17/18-MB1: Organic Farm Parking Lot Improvement, Indian Valley Campus

ADDENDUM #2

Bid Addendum No. 2

Date of Issuance: 02 August 2017
Project Name: College of Marin Indian Valley Campus
Organic Farm Parking Lot Improvements
Project Number: 1102-0005
Client: College of Marin

**SITE ACCESSIBILITY
PLAN**

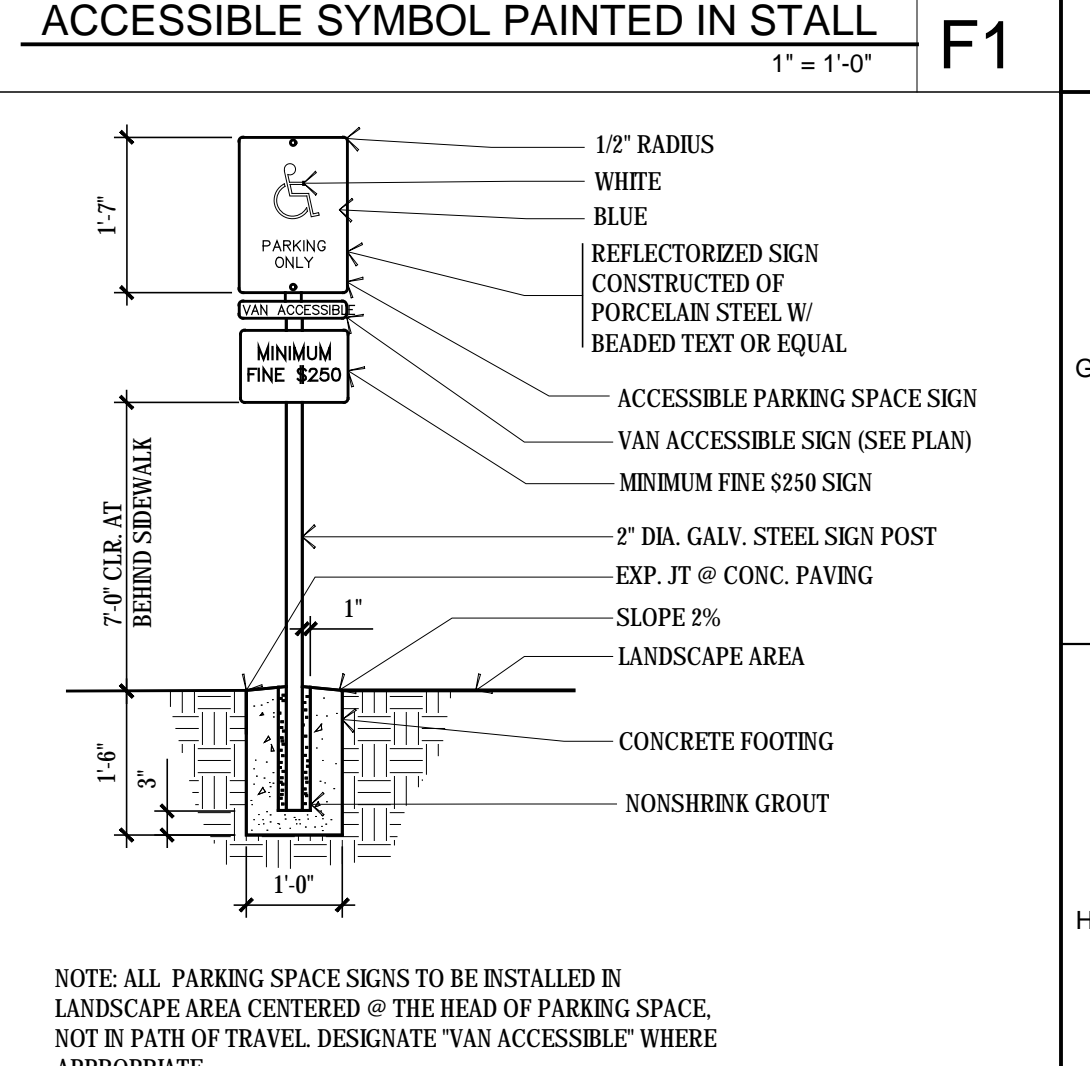
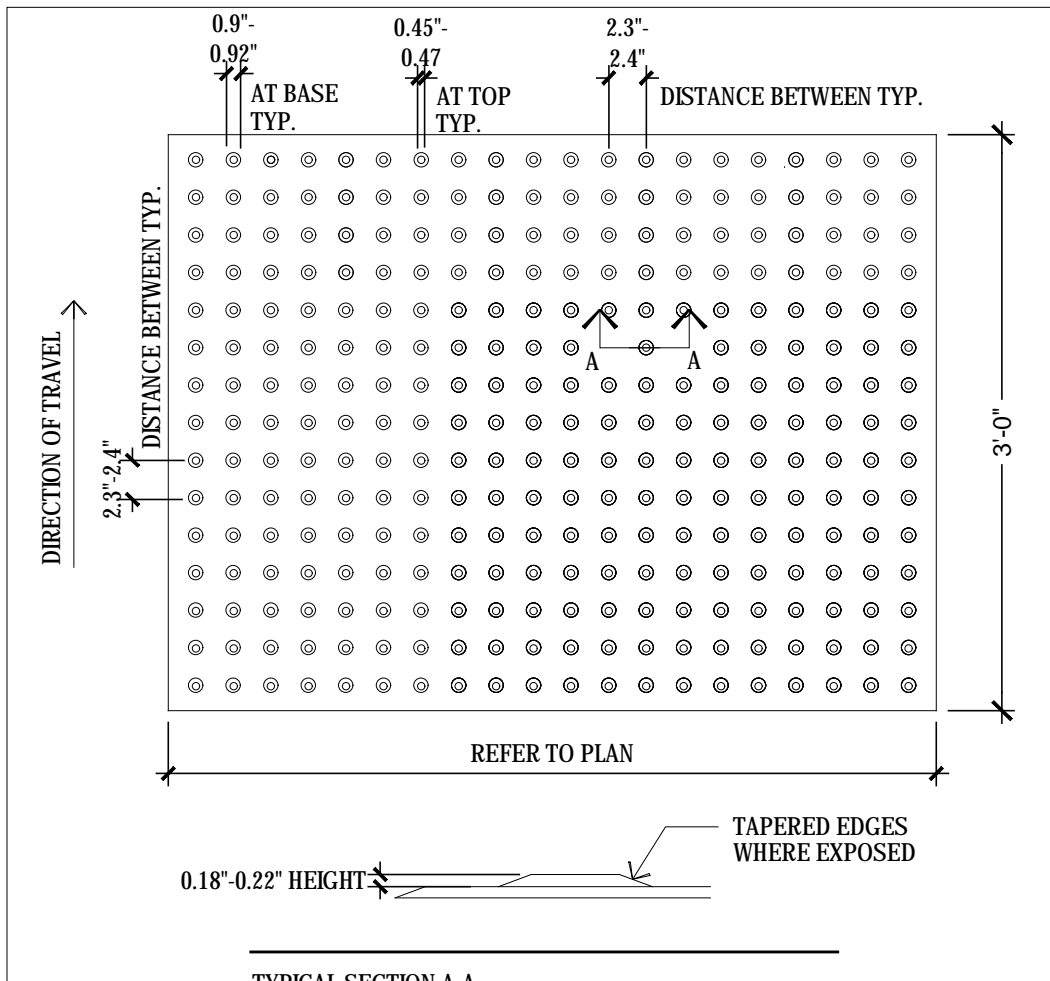
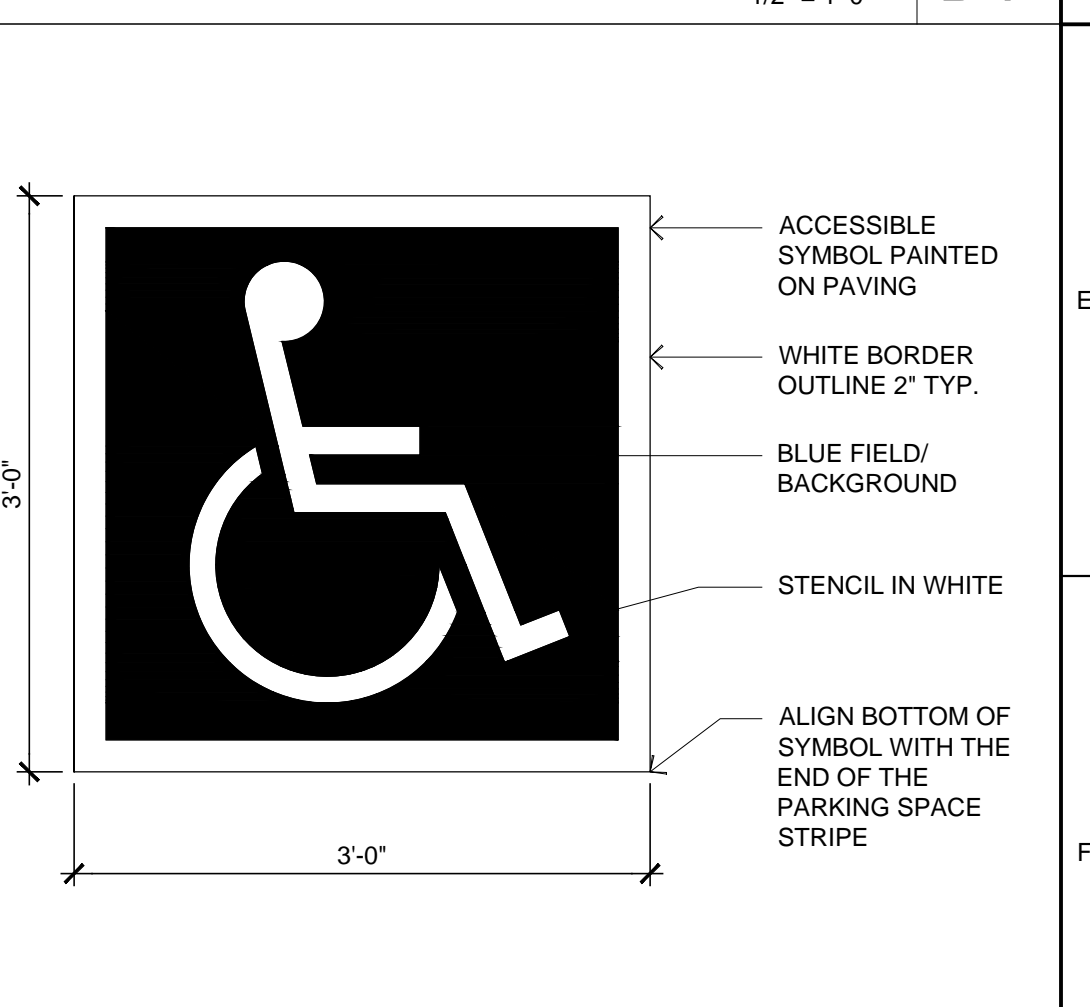
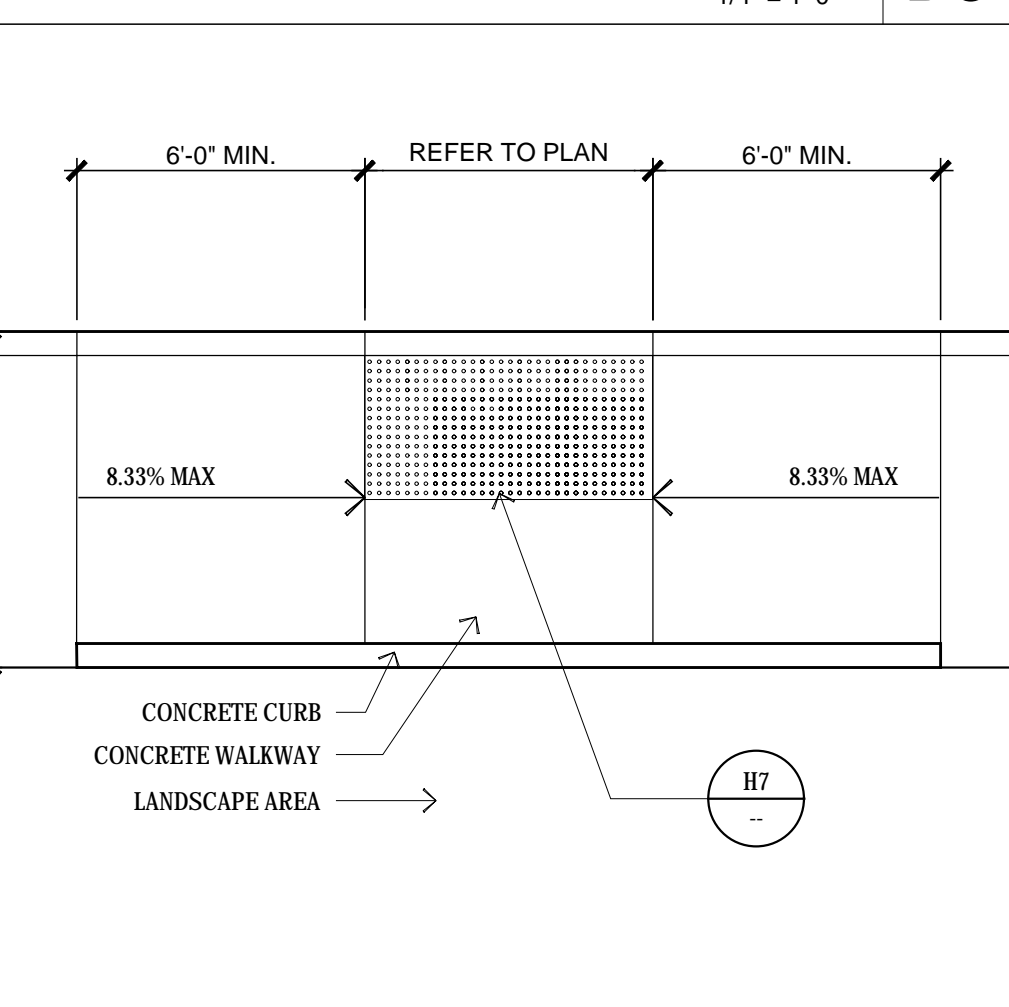
- A0.00 Index Sheet (Replacement sheet)
 - Added new sheets C1.00, C5.00.
 - Included sheet E0.02, previously issued but not listed
- A0.30 Site Accessibility Plan (Replacement Sheet)
 - Parking lot and stair layout revisions
- A0.31 Accessibility Details (Replacement sheet)
 - Detail revised, detail removed

DEMO PLAN

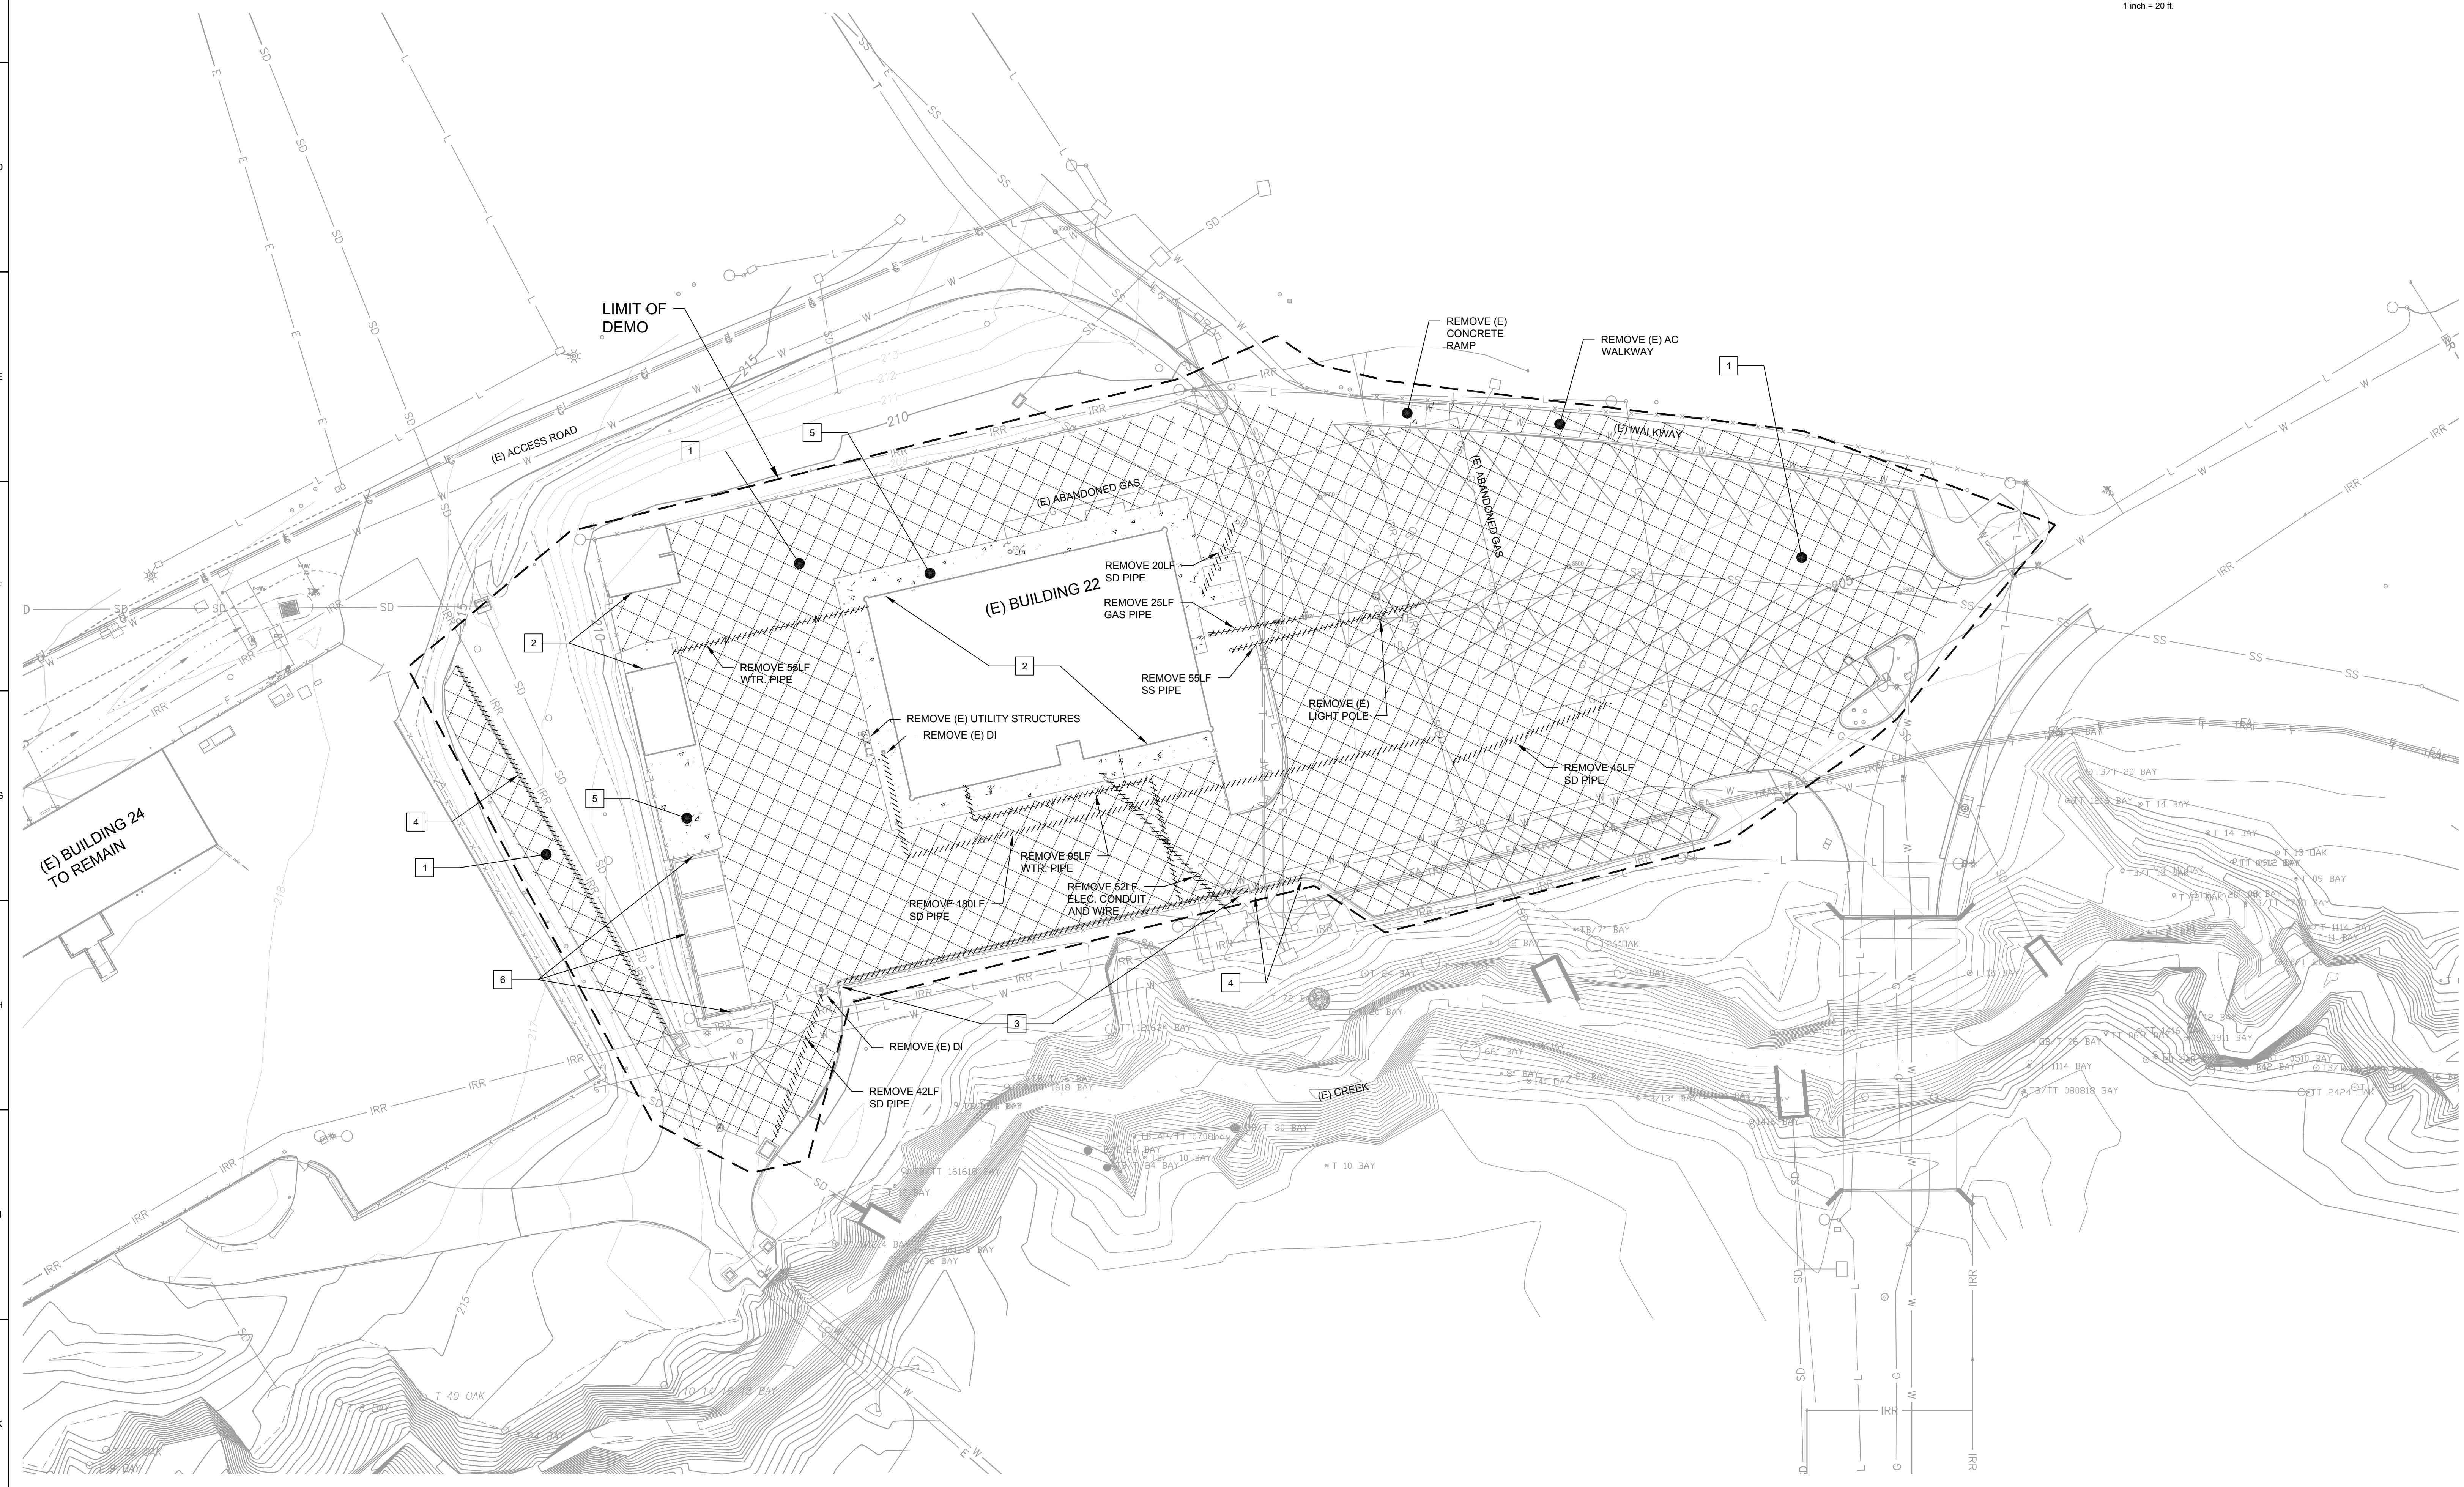
- C1.00 Demo Plan (New sheet)
- C2.0 Grading and Drainage Plan (Replacement Sheet)
 - Parking lot and stair layout revisions
- C3.0 Utility Plan (Replacement sheet)
 - Parking lot and stair layout revisions
- C4.0 Civil Details (Replacement Sheet)
 - Detail revisions
- C5.0 Erosion Control Plan (New Sheet)
